Subject: Notice of Project Change  
MGM Springfield, EEA #15033

Notice of Project Change  
*Submitted Pursuant to the Massachusetts Environmental Policy Act*

# **MEPA NOTICE OF PROJECT CHANGE FOR MGM SPRINGFIELD**

Attachment 2  
FEIR Site Plan

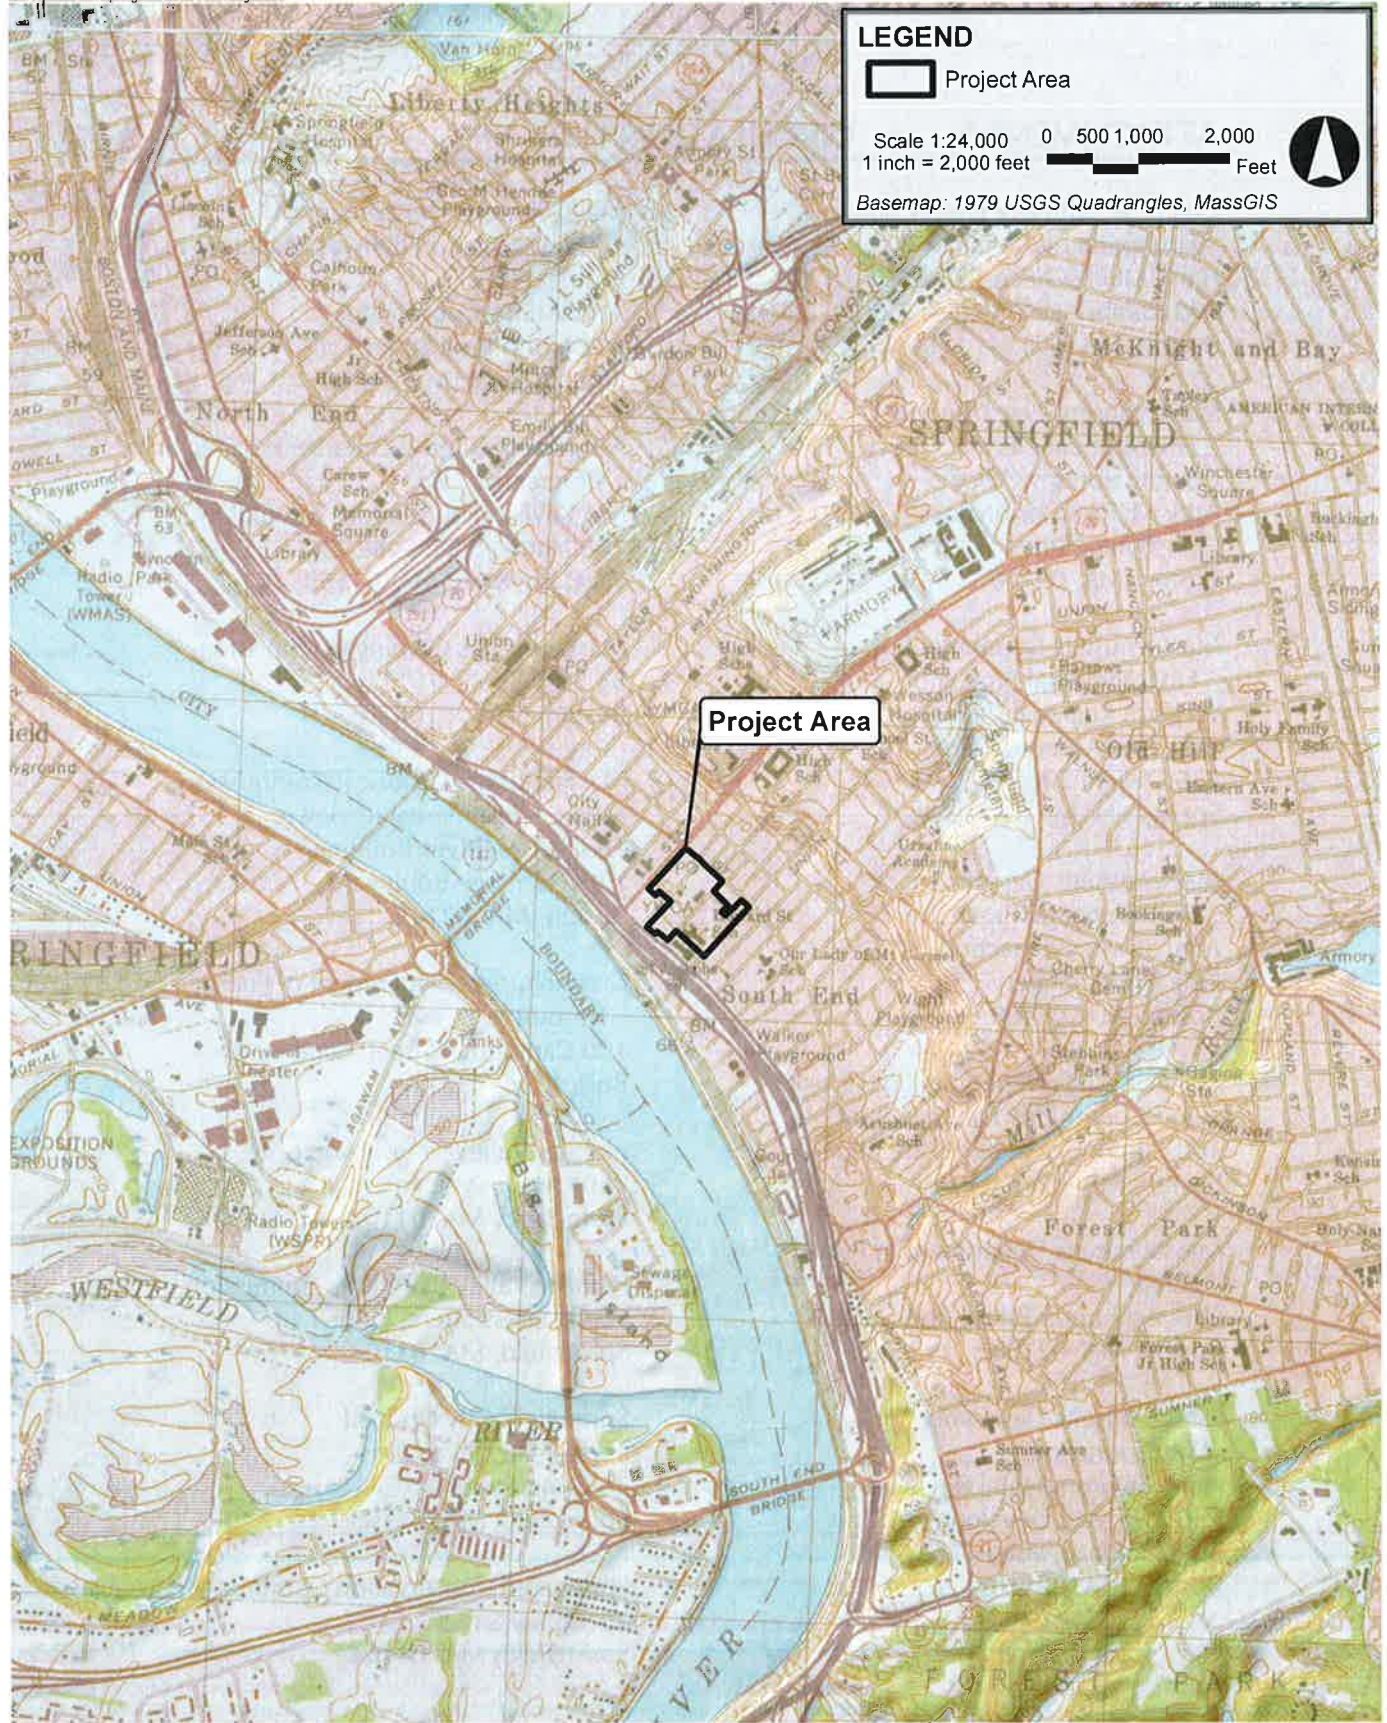
The FEIR Site Plan is included as Attachment 2.

- ◆ **Relocation and redesign of the hotel:** The FEIR included a 25-story glass skinned hotel adjacent to the western corner of the casino along State Street. The redesigned, six-story hotel will have the same number of rooms, but has been relocated to Main Street where the residential units were previously located. Locating the hotel entrance on Main Street will provide increased opportunities for

# 2 Dome at Banquet Area

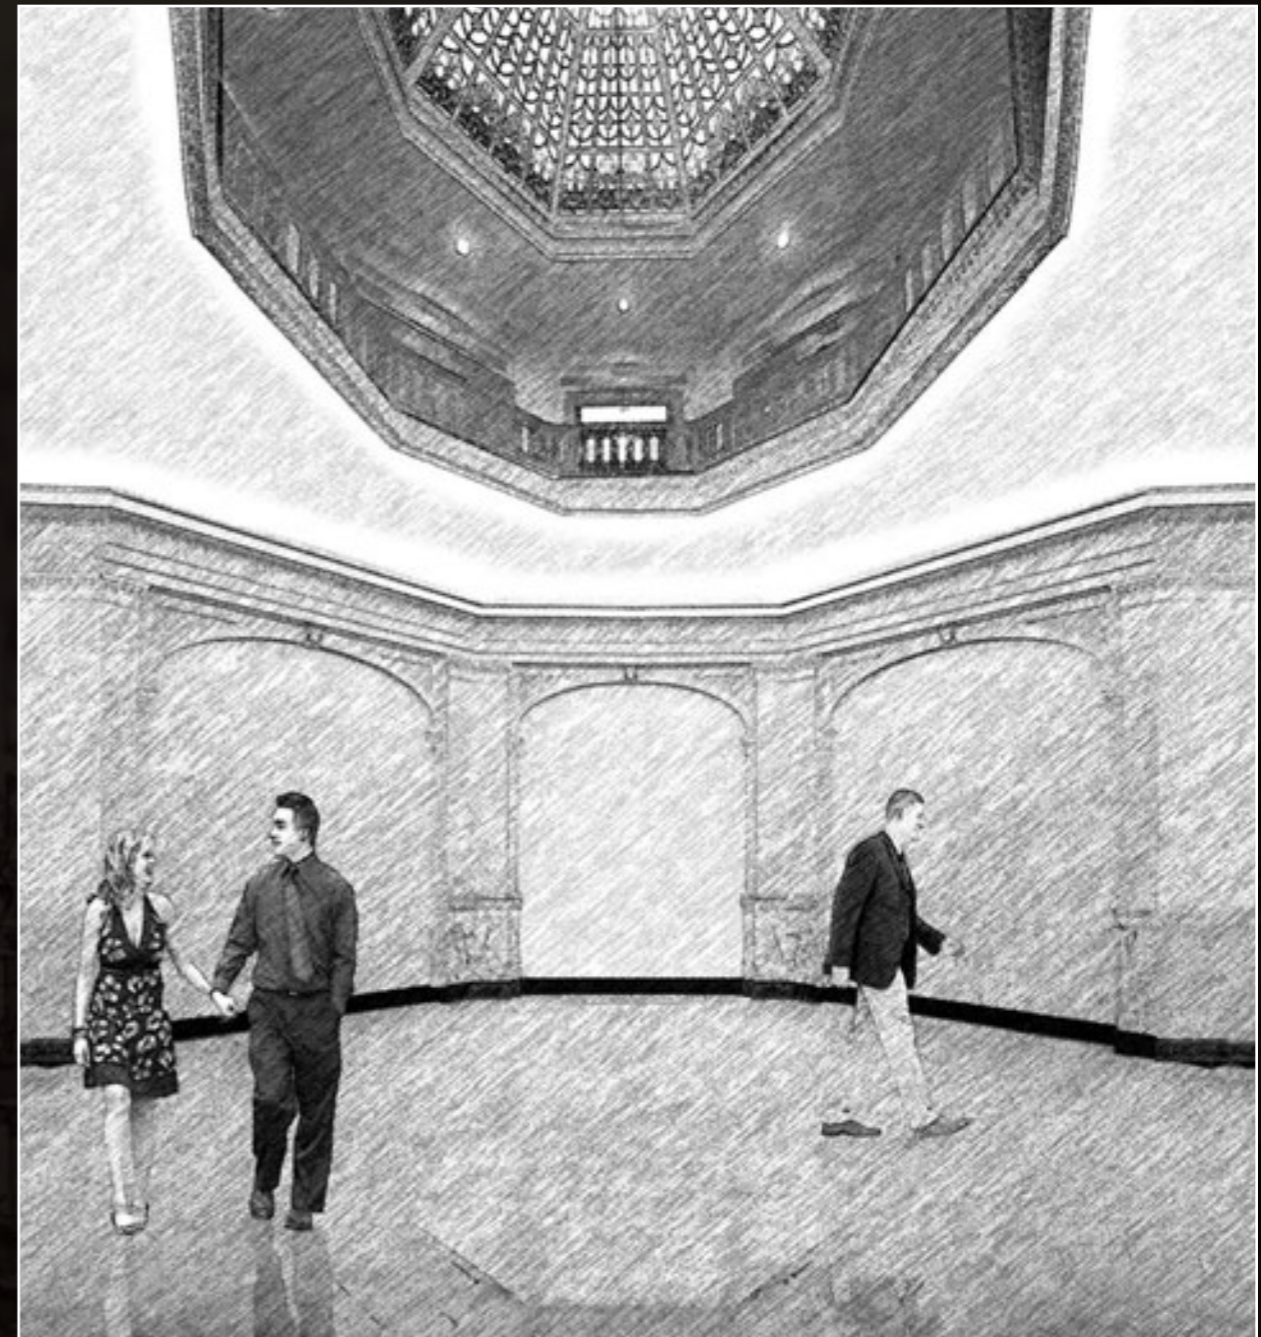
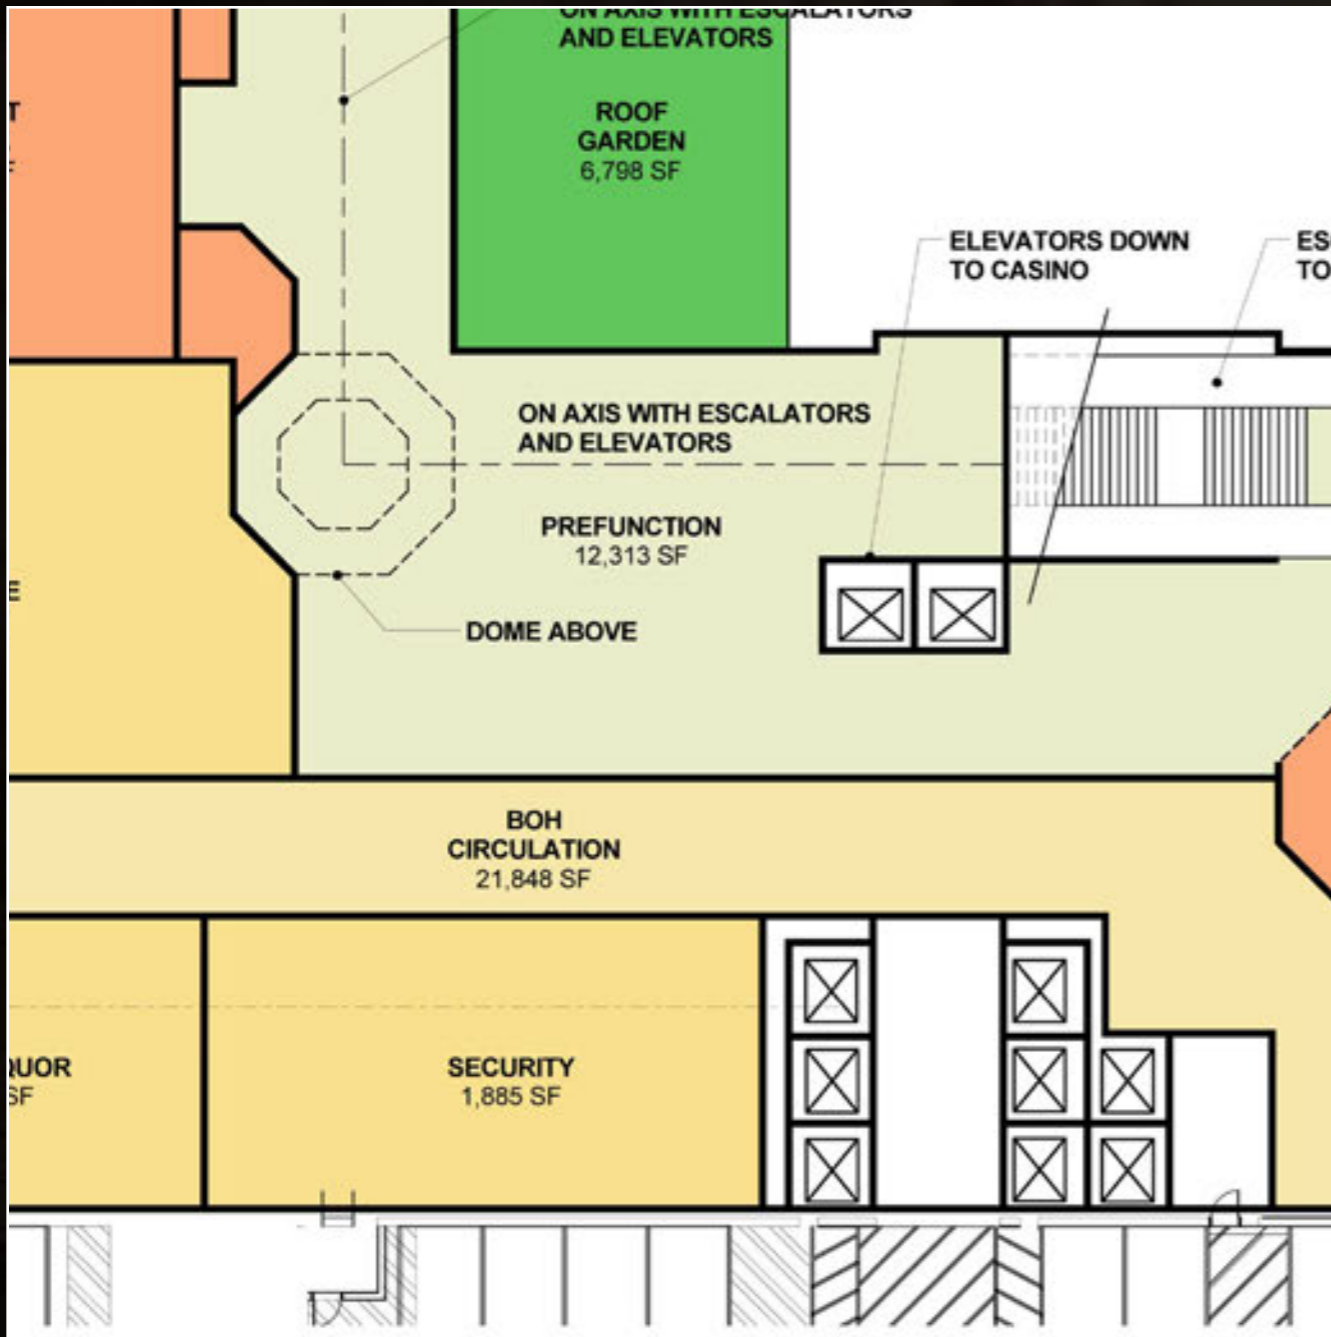
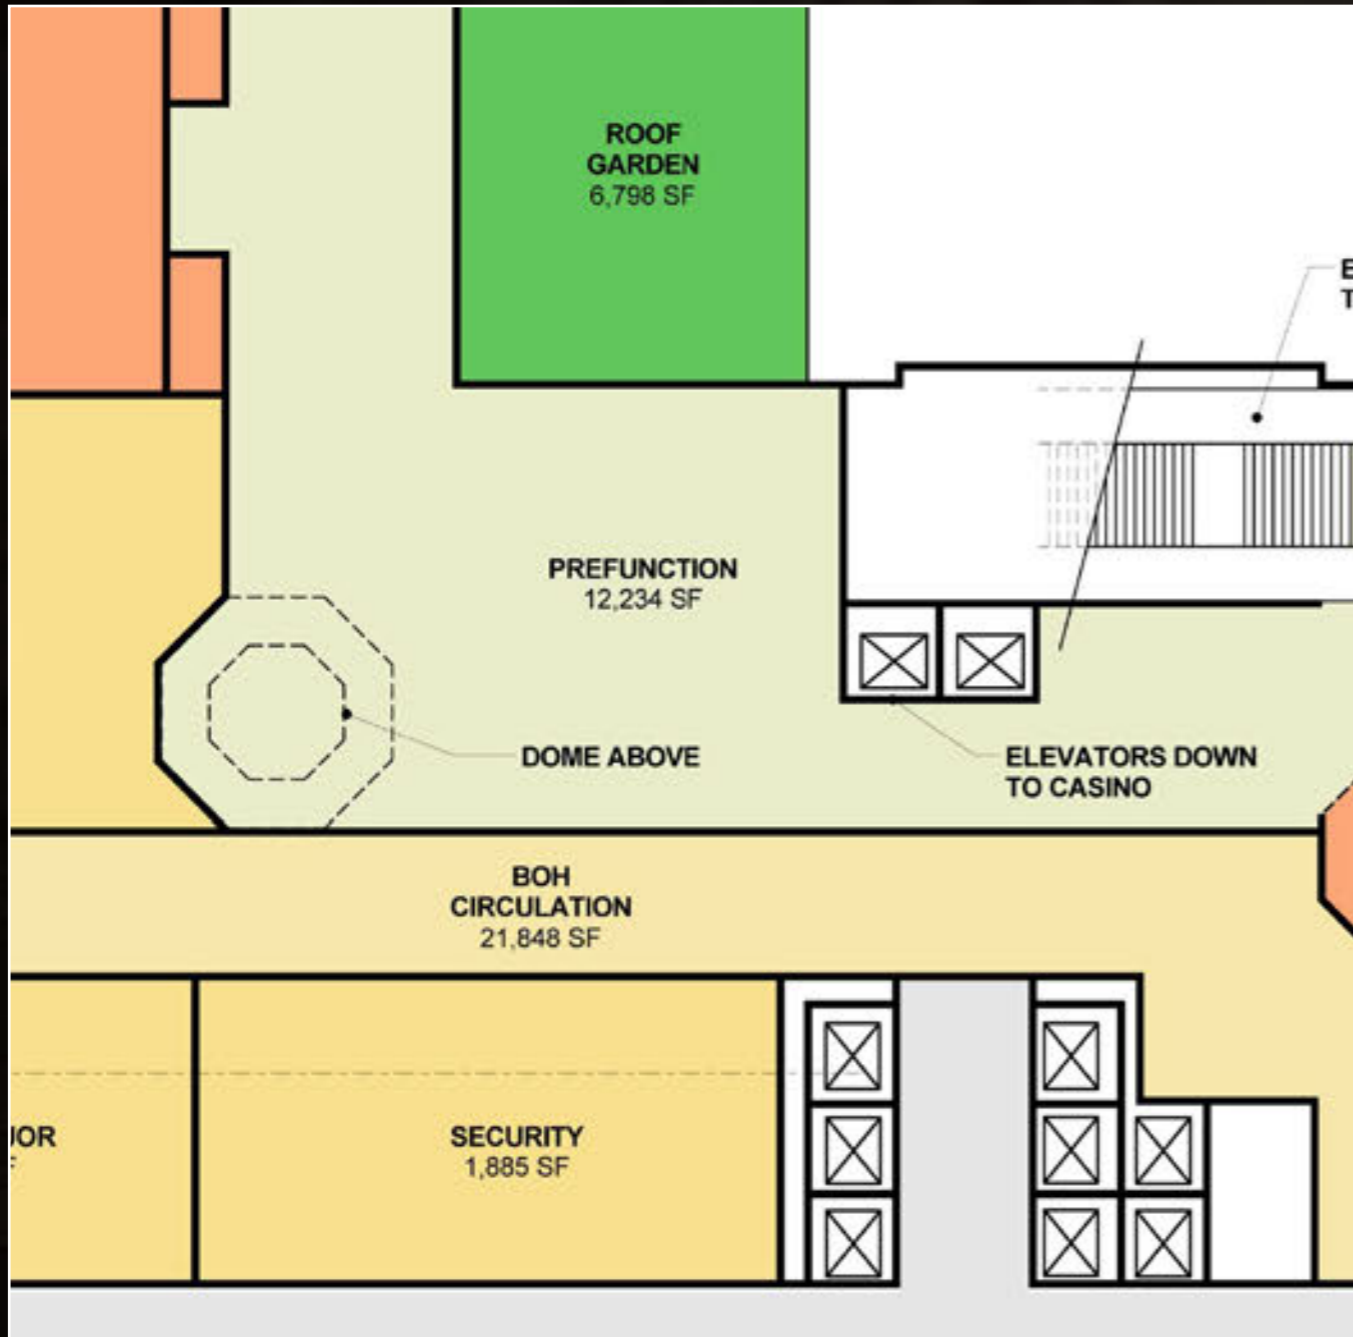
## PREVIOUS APPROVED PROPOSAL

## CURRENT PROPOSAL - OPTION 1

## CURRENT PROPOSAL - OPTION 2

# 3 Union House/ Chandler Hotel

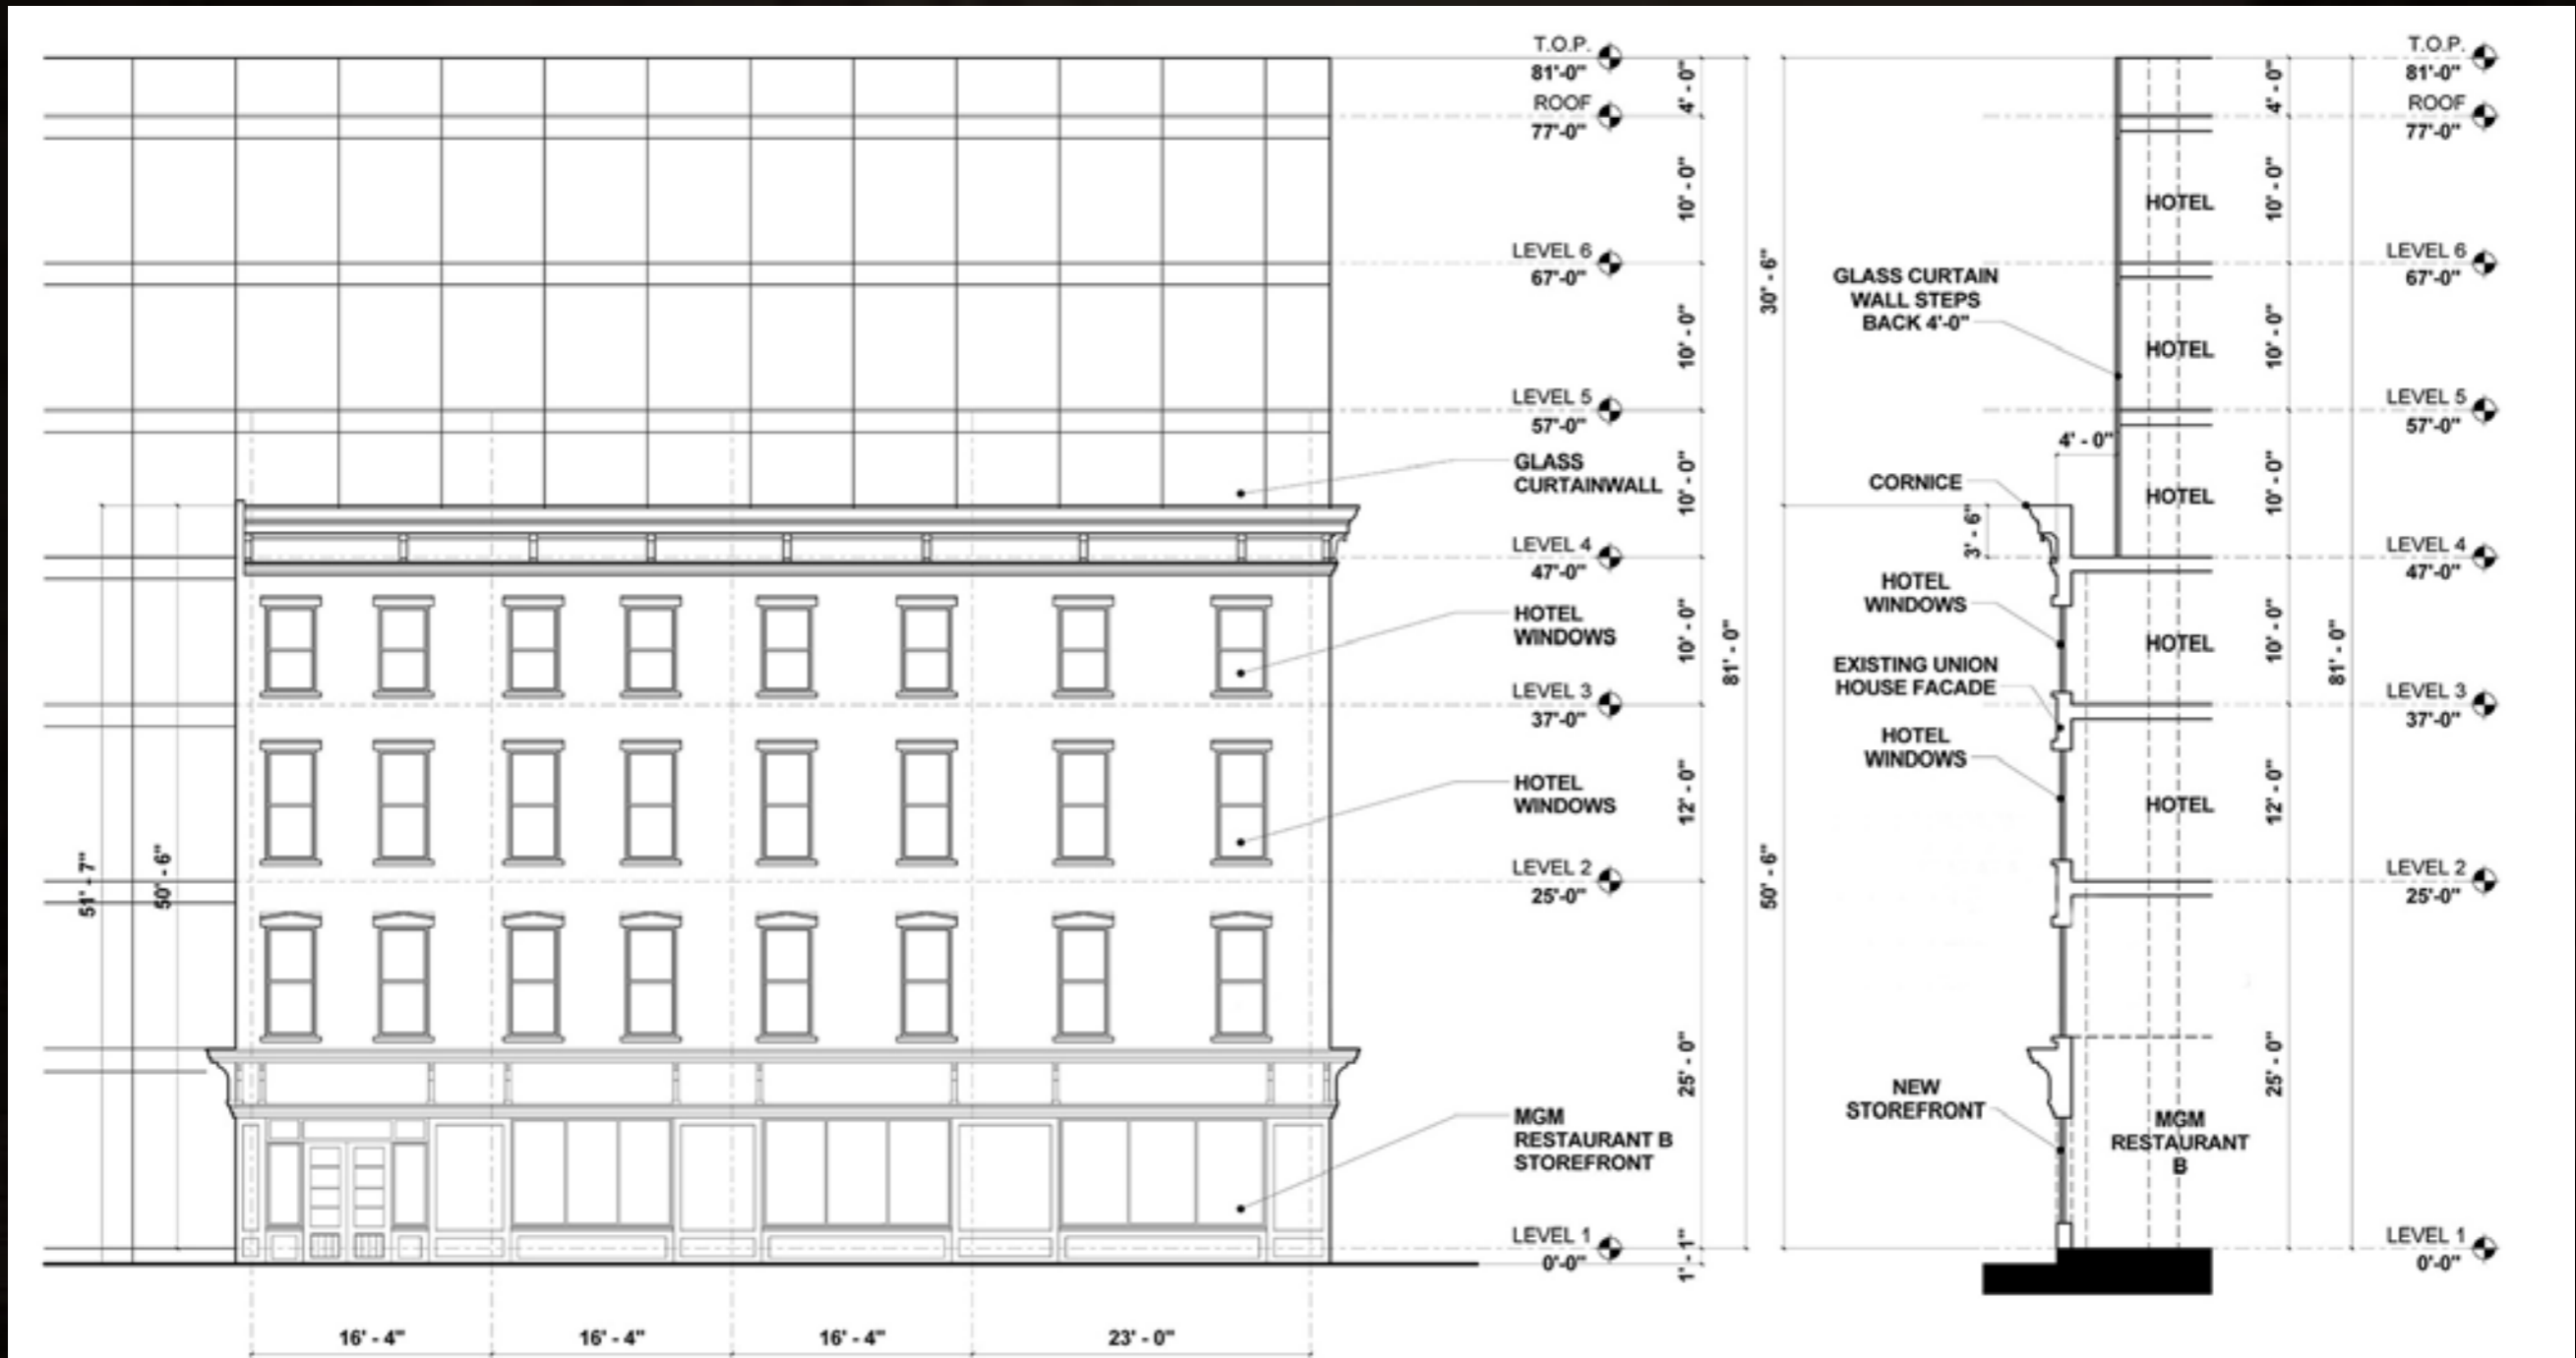
## PREVIOUS PROPOSAL

## CURRENT PROPOSAL
